COMMENTS / FEEDBACK / OBSERVATIONS / SUGGESTIONS

Window 4: Exodus (The 10 Plagues)

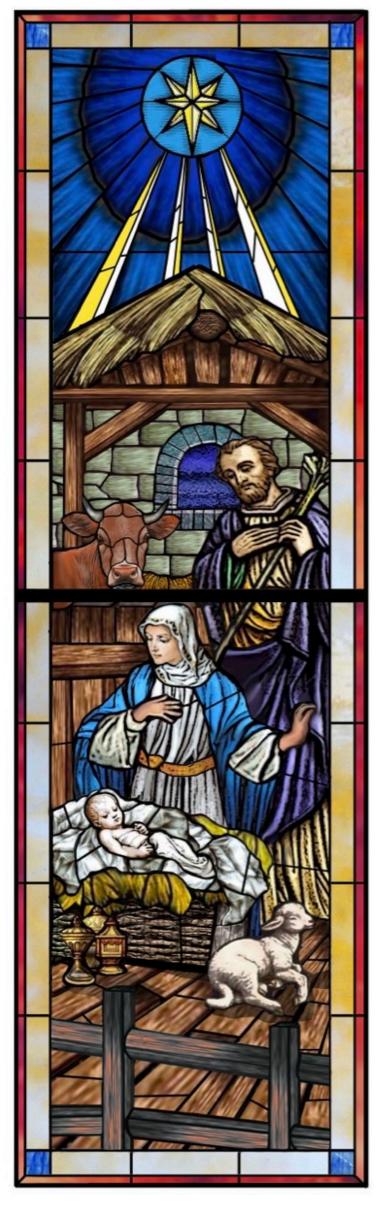
The 10 Plagues are a great part of the God's story of deliverance (but only part) with the **Passover lamb** pointing to the Lamb of God who takes away the sin of the world, ... another possiblity we could consider is placing the Plagues in the top part of the window, then the passing through the Red Sea in the center and in the lower part the giving of the Ten Commandments. It might be busier than some of the other windows but all are important parts of the God's deliverance—the Passover Lamb connected to Holy Communion, the passing of the Red Sea connected to **Baptism**, and the 10 Commandments still extend to us today as a guide for our lives (even though one could say they are the Old Covenant vs. the New Covenant in Christ). Let us know your thoughts.

Window 7: Jesus' suffering

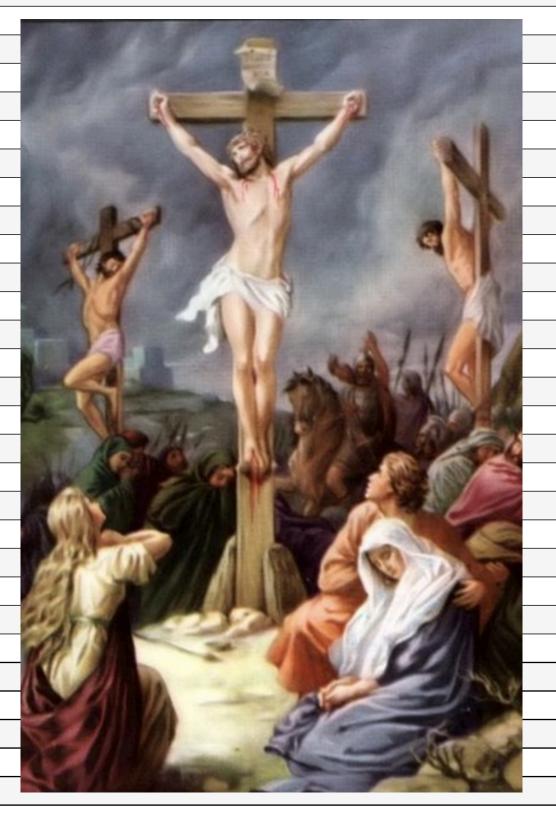
Rather than focusing on the journey to the cross, thought was given to the fact that we perhaps we ought to focus on the Passion. A rework hasn't been done yet but something like this is envisioned.

Window 8: Resurrection & Ascension

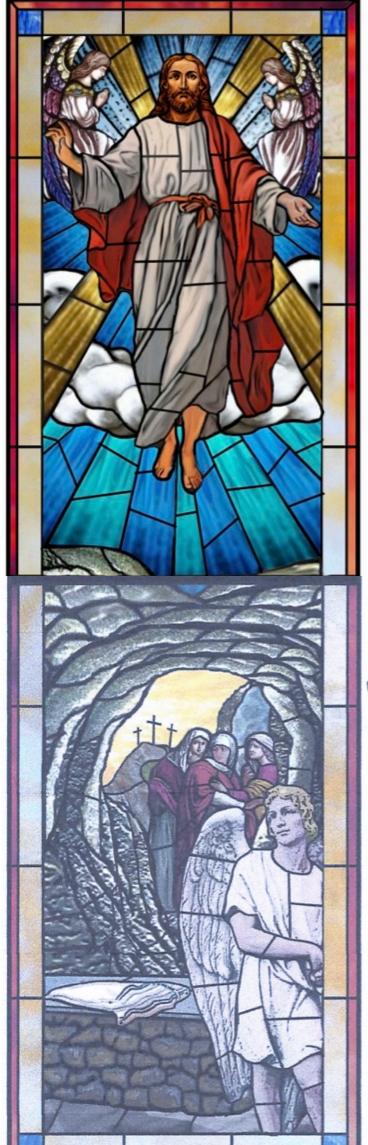
Still need to correct the resurrection scene so that the slab with the folded burial cloths is more visible. (Also the angel is described as looking like a man not a woman.). I think portraying wings is fine even though it might be an embellishment of the text. Below is a sketch of how we envision it. The angel and slab oriented this way with him greeting the women and gesturing toward the slab and the folded burial cloths.

REWORKED Shouldn't the angel be facing the women? Would the slab have to look man-made (i.e. built from stones) or could it look more like it was carved out of living rock? Also, since most of the Holy Land appears to look more like sandstone, could we shift the color a bit away from gray (and would that make the stained glass more appealing)? The same consideration might be given to the current Window 4 masonry in the Passover scene)
